From: Larry Bastian <larry@terradynconsultants.com>
Sent: Monday, December 17, 2018 2:05 PM
To: Amanda L. Lessard
Cc: Jim Cummings (jimcummings111@gmail.com); Jeff Amos
Subject: Cook Road Retirement Community - Response to Review Comments
Attachments: 18218 Cook Rd Retirement Community Rev Figure 2 to Show Nitrate Plume.pdf; Response to J Earle Comments.pdf; USGS Watersheds_Cook Rd.pdf

TERRADYN RESPONSE TO COMMENTS NOTED IN BOLD ITALICS

From: Jonathan R. Earle
Sent: Friday, November 30, 2018 3:09 PM
To: 'Jeff Amos, P.E. '; Amanda L. Lessard
Subject: 18-31 Cook Road Retirement Community - Preliminary Plan Review Comments

PROJECT: COOK ROAD RETIREMENT COMMUNITY 306 GRAY ROAD - WINDHAM, ME	CLIENT: JIM CUMMINGS	TITLE: NITRATE-NITROGEN ASSESSMENT SITE PLAN	
		SCALE: 1" = 80'	DRAWN BY: KRF
DATE: DECEMBER 14, 2018		APPR BY: SBM	
173 PLEASANT STREET ROCKLAND, ME 04841 Tel: (207) 318-1161		SUMMIT GEOENGINEERING SERVICES	
145 LEBRON ST. - SUITE 101 LEWISTON, ME 04240 Tel: (207) 516-3313		PROJ.#: 18218	
FIGURE: 2

Routing Diagram for 1841 PRE

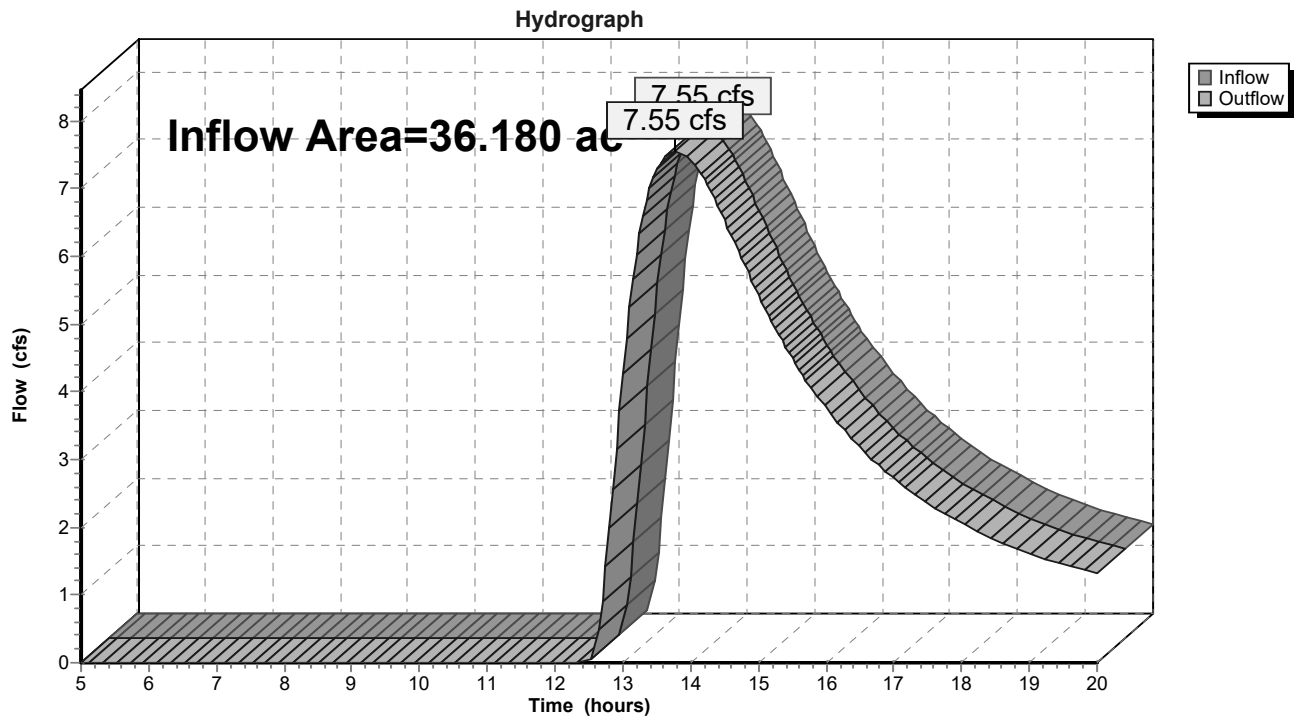
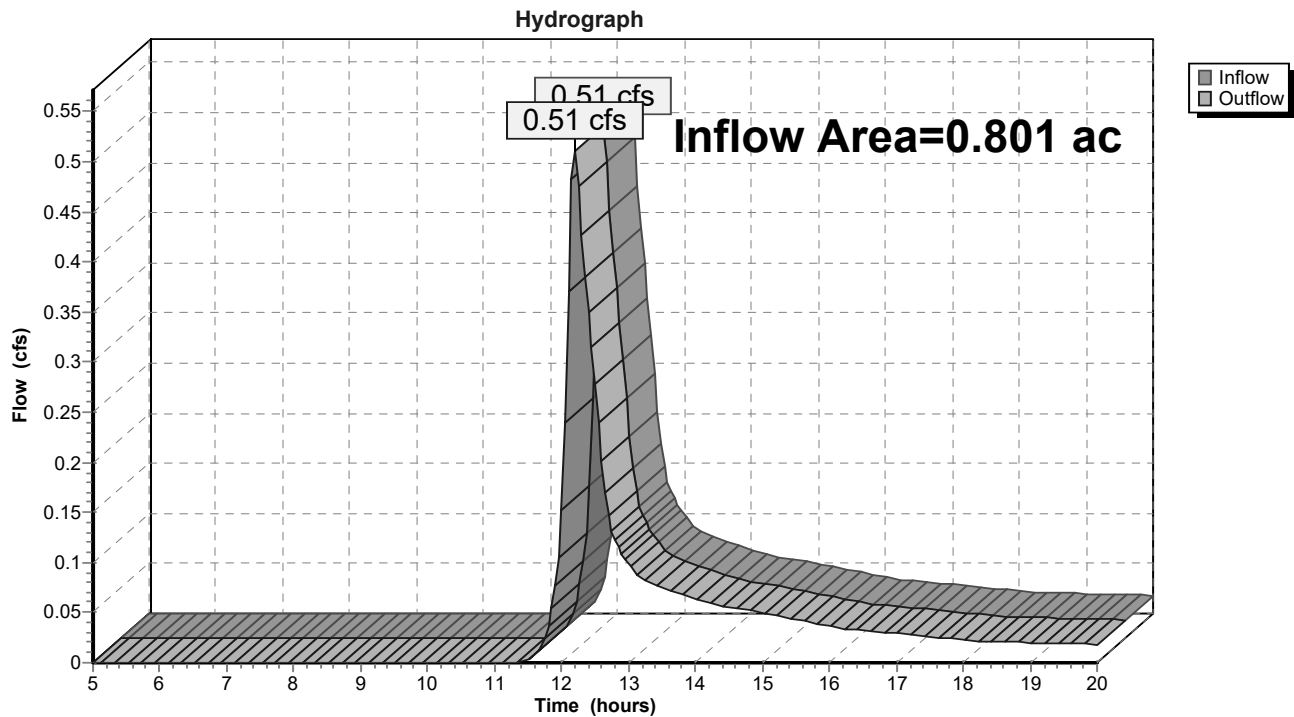
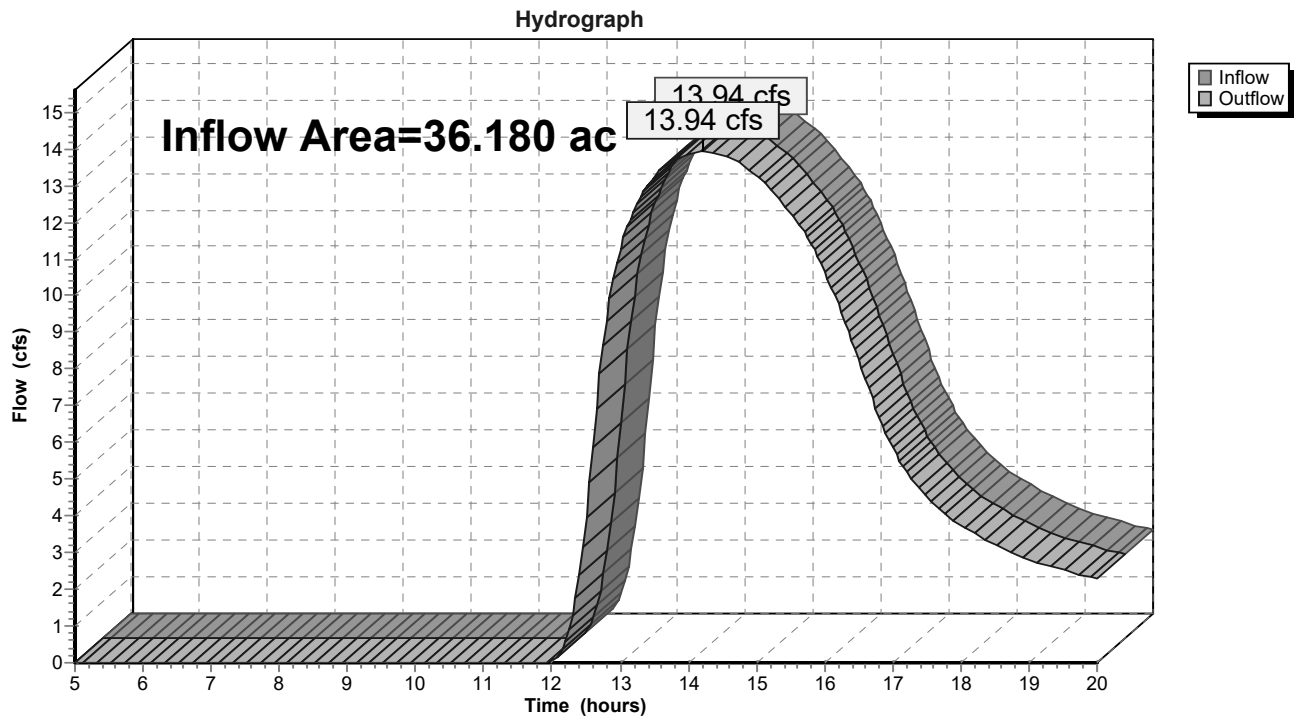
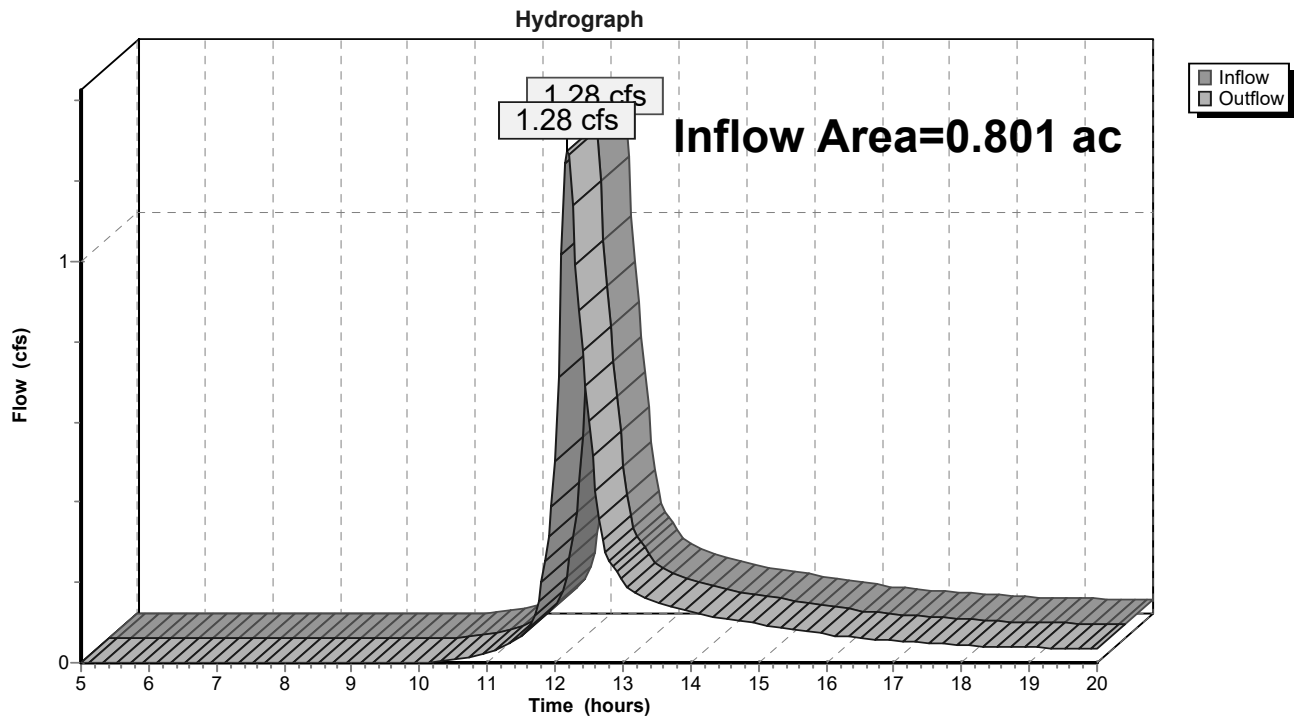
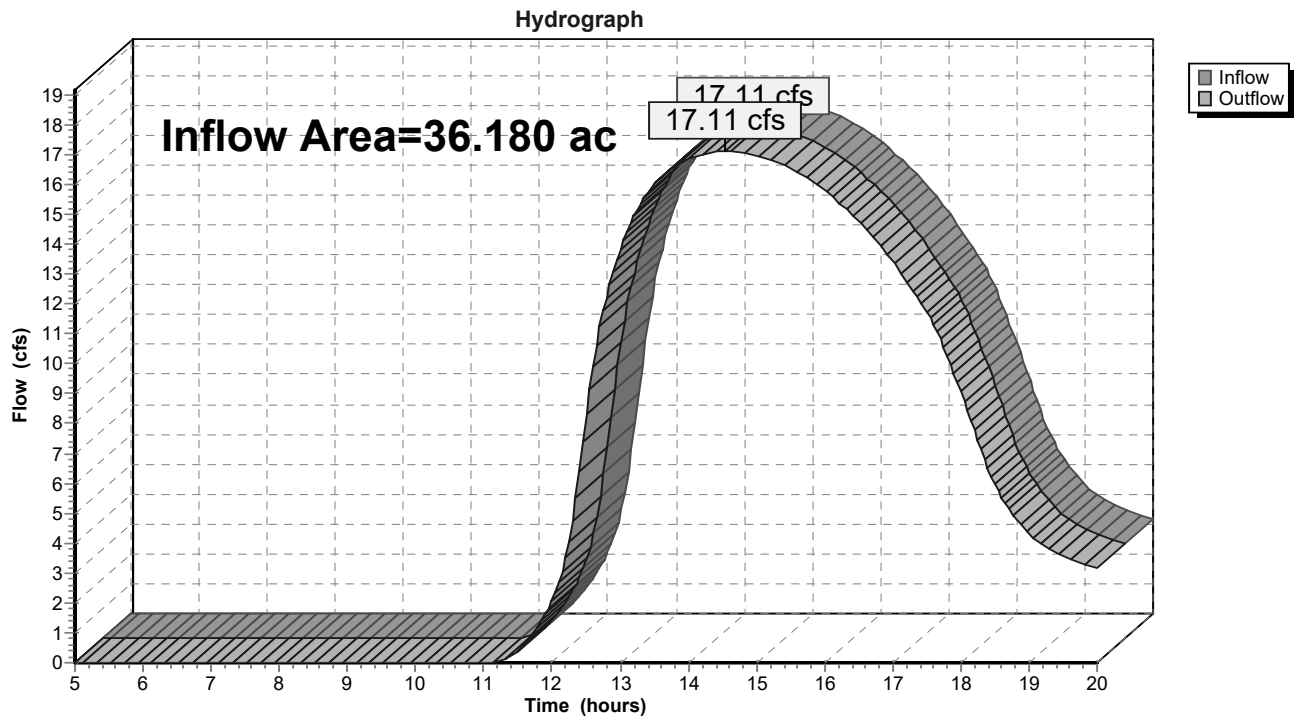
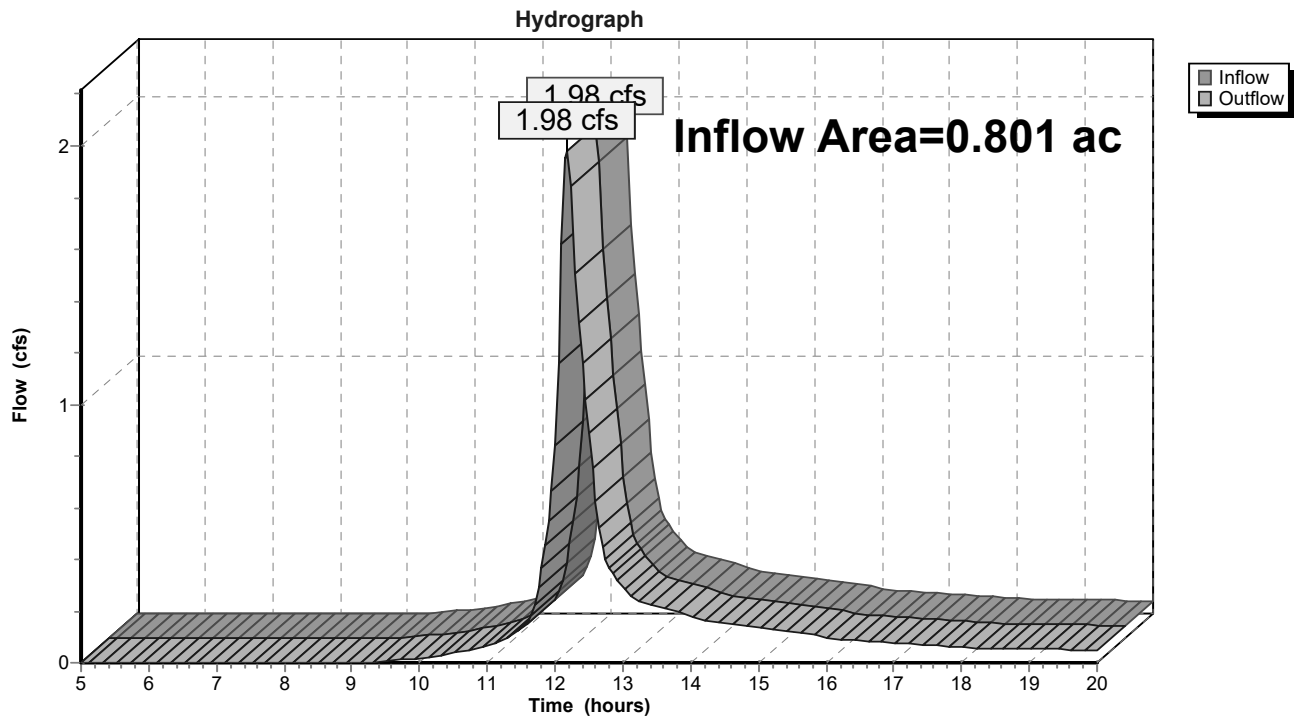
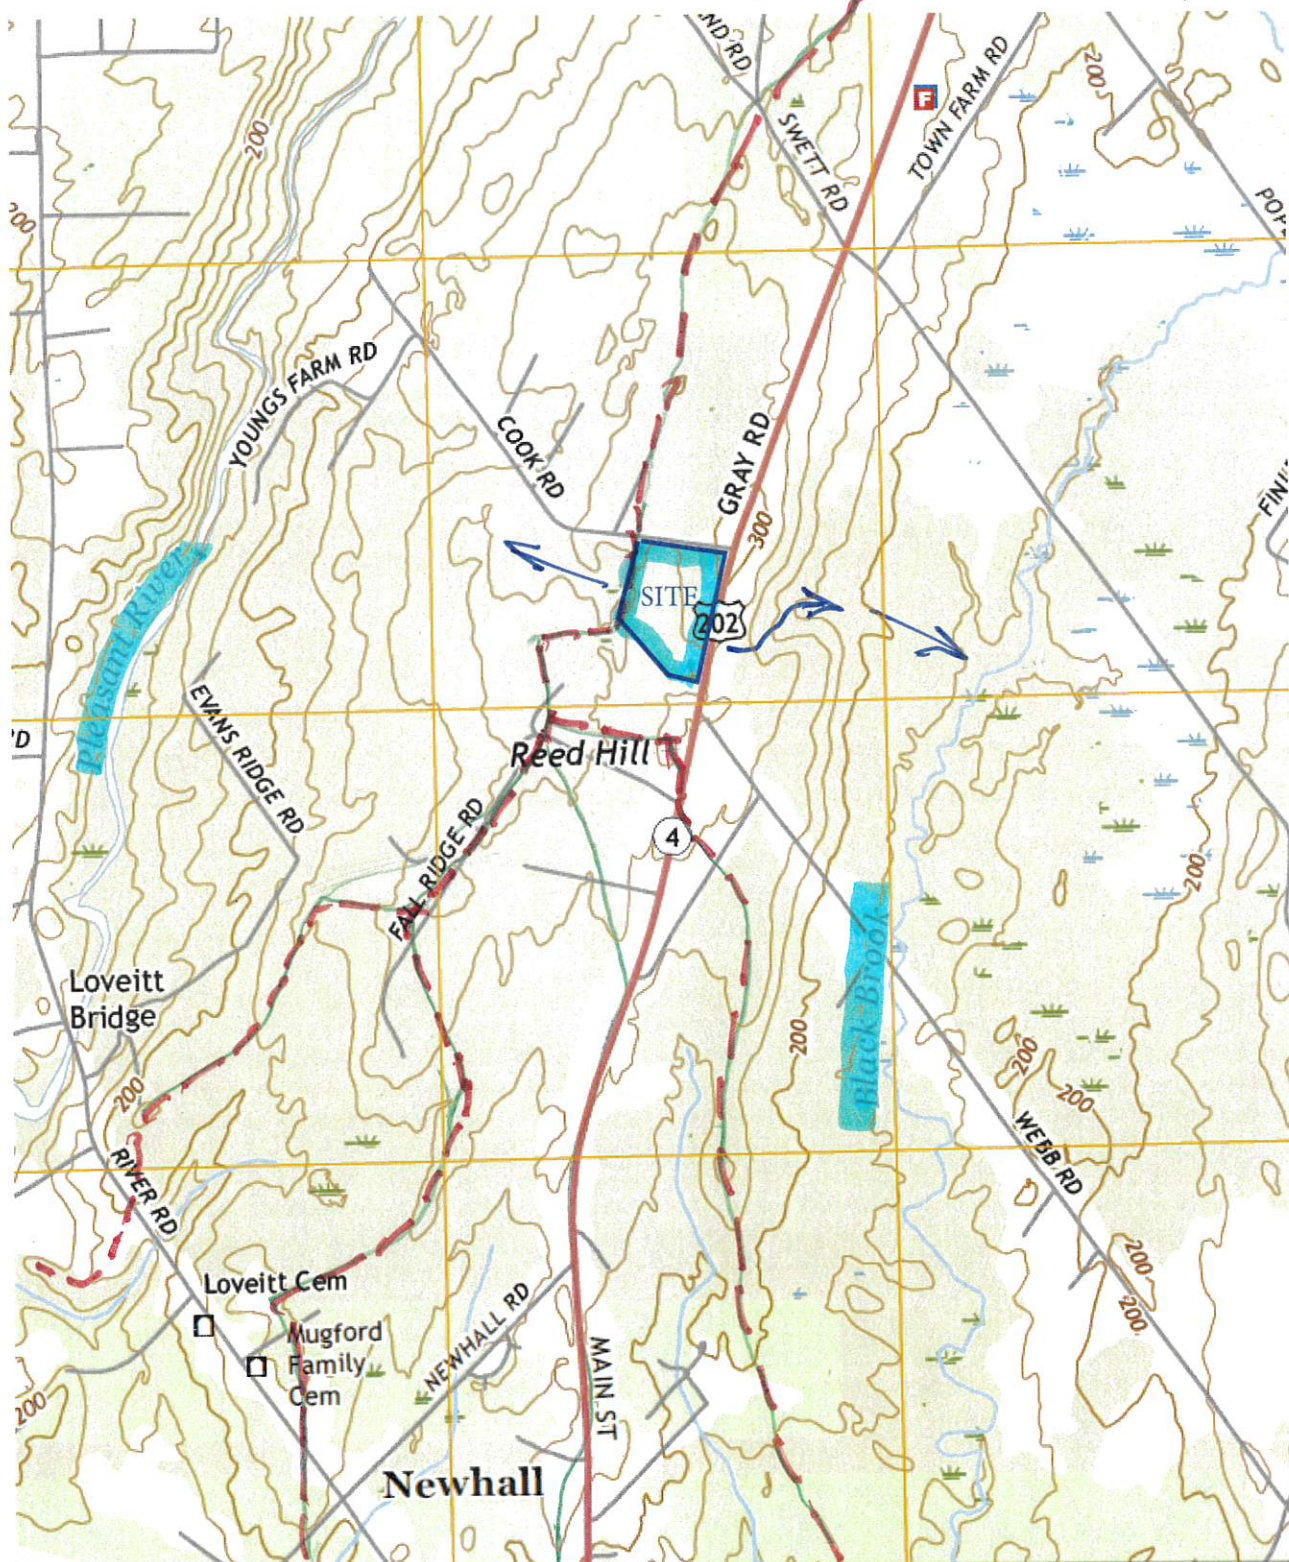
5. Stormwater
 - a. Basic Standards – An erosion and sedimentation control plan has been provided that meet these standards.
 - b. General Standard – The narrative indicates that 99 % of impervious and 84 % of the developed areas are being treated by BMP which exceeds the standard. Table is shown to confirm these calculations on Sheet C 6.1
 - c. Flooding Standard – The narrative indicates the postdevelopment flows at the two study points are at or below predevelopment levels. The HydroCAD calculation for the predevelopment conditions do not include the study point reaches for each storm event. Please provide these to verify the table in the stormwater report narrative.

HydroCAD output for these study points is attached. Calculated flows match the previously submitted narrative.
